Interactive comment on “Forchheimer flow to a well considering time-dependent critical radius” by Q. Wang et al.

Interactive comment on Hydrol. Earth Syst. Sci. Discuss., 10, 14095, 2013.

Fig. 2. Fig. 2a. Specific discharge distributions with different critical radius RCD.

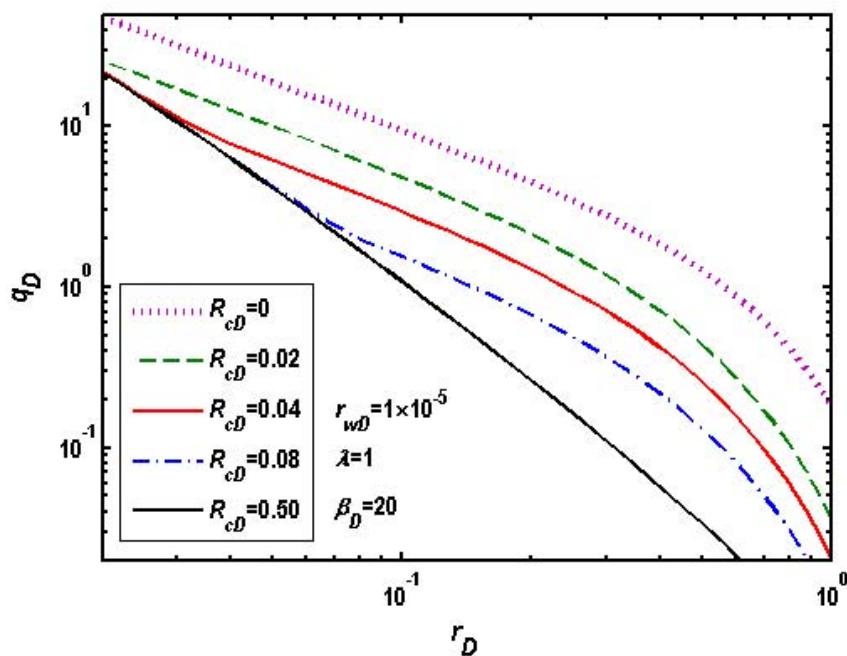
Figures: 1. figure 2a: dotted lines are very difficult to distinguish Reply: We have revised it (see Fig. 2a).

7. figure 5,7,8: recommendation of using the same linestyle in all plots (same lines for the same values in beta) and keeping the order in the legend constant dimensions are missing at labels (Figs. 2, 4-8) Reply: We have revised them (see Figs. 2, 4-8).

Fig. 3. Fig. 2b. The schematic diagram showing the iterative process of seeking RCD.

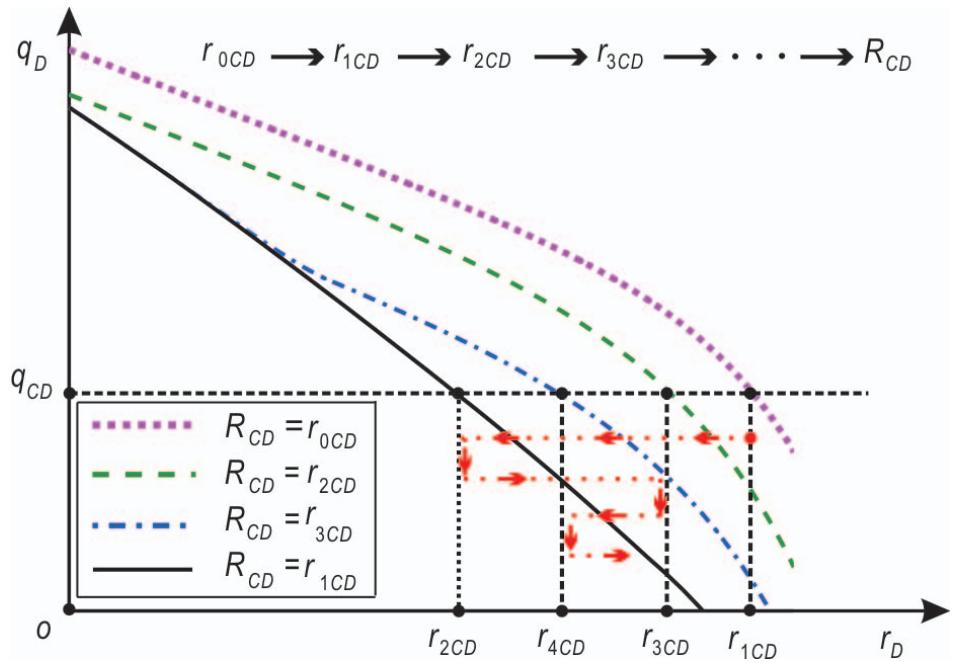
2. figure 2b: lines in legend difficult to refer to lines in the plot Reply: We have revised it (see Fig. 2b).

Fig. 5. Fig. 4a. Comparison of the distance-drawdowns by the fully Darcian flow model (Papadopoulos and Cooper, 1967), the fully non-Darcian flow model (Mathias et al., 2008), the two-region flow model (Sen,

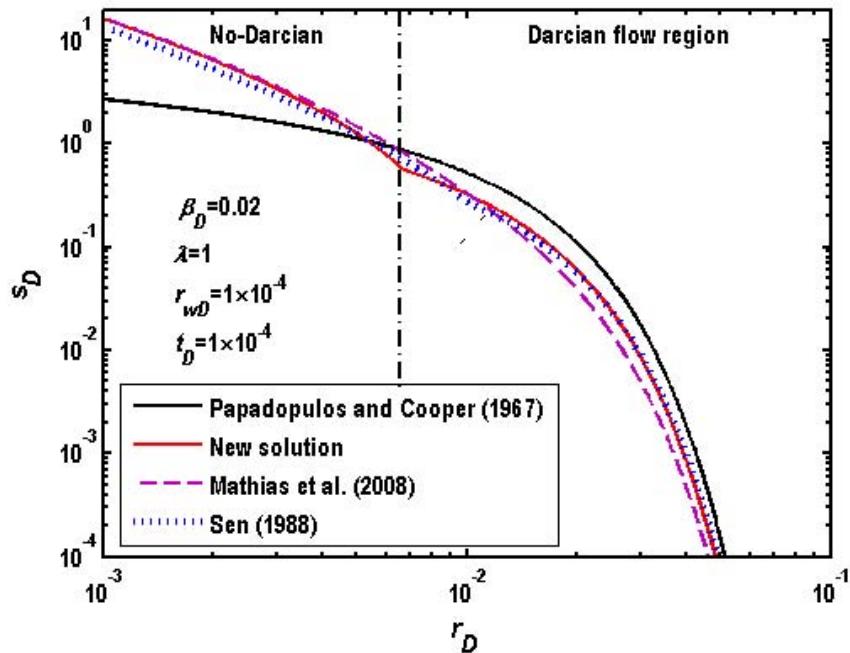
10. p14109: line 10: specify what figures 4a and b show: a comparison of the distance drawdown curves for all 4 models/solutions Reply: We have revised it (see P19 Lines 17-20).

3. figure 4a,4b: either in the legend or in the caption should be assigned which flow model (Darcian, fully non-Darcian,...) refers to which model/solution (Mathias et al. (2008)...) dotted lines are very difficult to distinguish (4a), recommendation of using the same linestyle in both plots Reply: We have revised it (see Figs. 4a-4b; P31 Lines 7-12).

Fig. 6. Fig. 4b. Comparison of the distance-drawdowns by the fully Darcian flow model (Papadopoulos and Cooper, 1967), the fully non-Darcian flow model (Mathias et al., 2008), the two-region flow model (Sen,

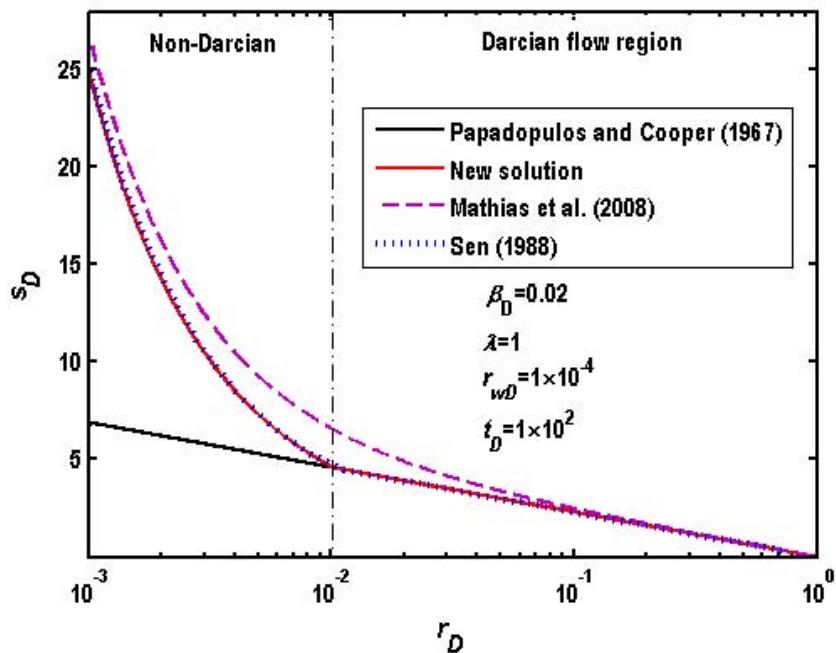
10. p14110: line 15: "Another fact that can be seen in Fig. 4b is that the new solution..." Reply: We have revised it (see P20 Line 20; P21 Lines 1-2).

Fig. 7. Fig. 5. Time-dependent critical radius (RCD) for different inertial force coefficients.

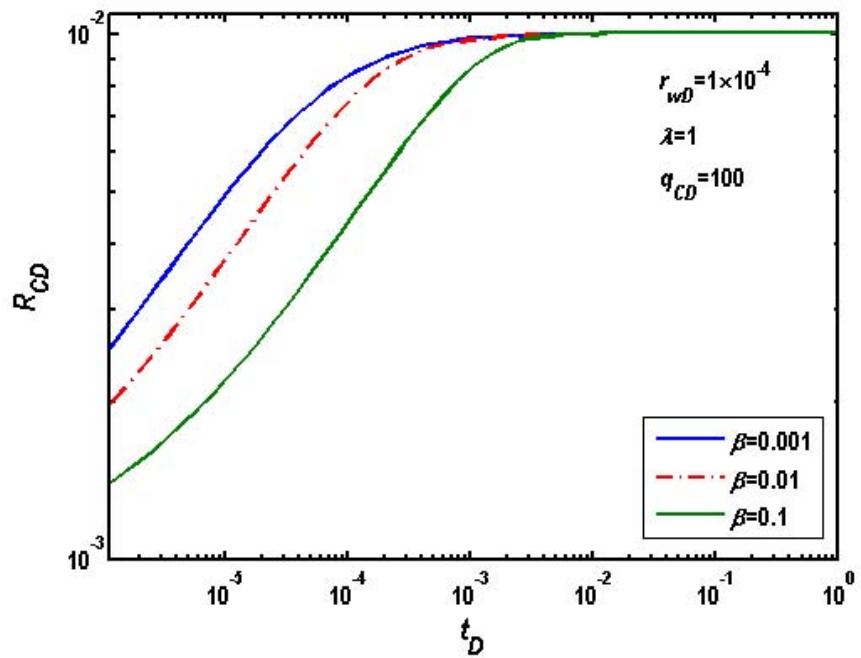
4. figure 5: specify the caption: the plot shows the time-dependent critical radius

$R_{CD}(t)$ for different values of the inertial force coefficient beta Reply: We have revised it (see P31 Line 13).

Fig. 8. Fig. 6. Time-dependent critical radius (RCD) for different critical specific discharges.

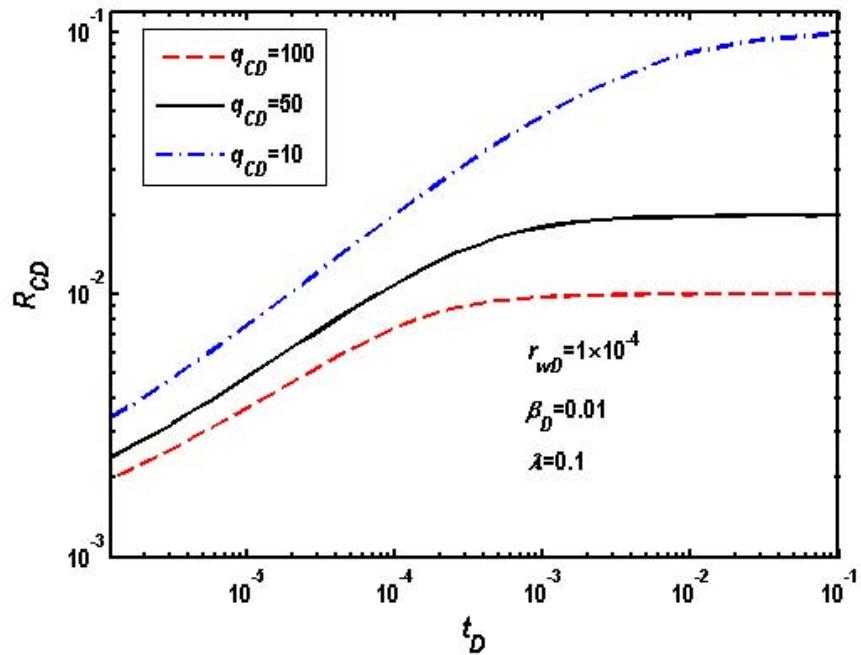
5. figure 6: specify the caption: the plot shows the time-dependent critical radius $R_{CD}(t)$ for different values of the critical specific discharge Reply: We have revised it (see P31 Line 14).

Fig. 9. Fig. 7. Time-drawdown at $rD=0.005$ for different inertial force coefficients in a log-log scale.

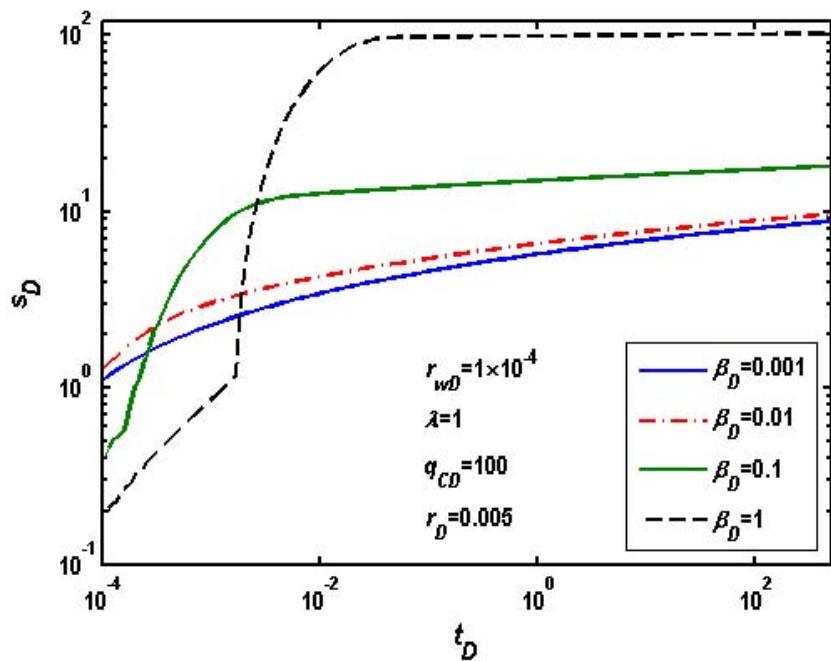
6. figure 7/8: Why using different scales at the y-axis? Recommendation of using log-log-plots for both figures Reply: We have revised them and plotted two figures in the log-log coordinate system (see Figs. 7 and 8).

Fig. 10. Fig. 8. Time-drawdown at $rD=0.02$ for different inertial force coefficients in a log-log scale.

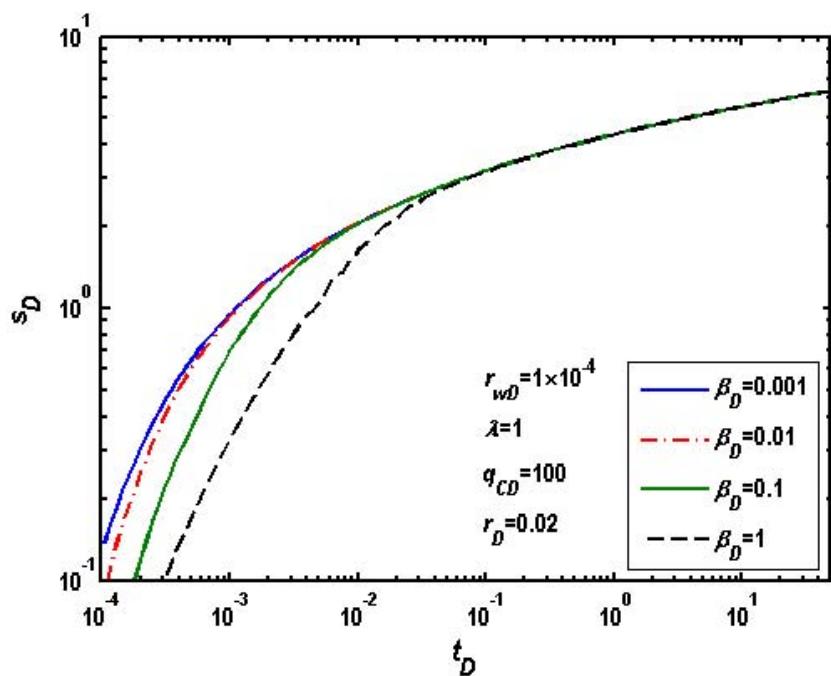
12. p14113: line 2: Why $r_D=0.1$, when explaining figure 8 which refers to $r_D=1$? Reply: We corrected it, and $rD=0.02$ (see P23 Lines 14-15).
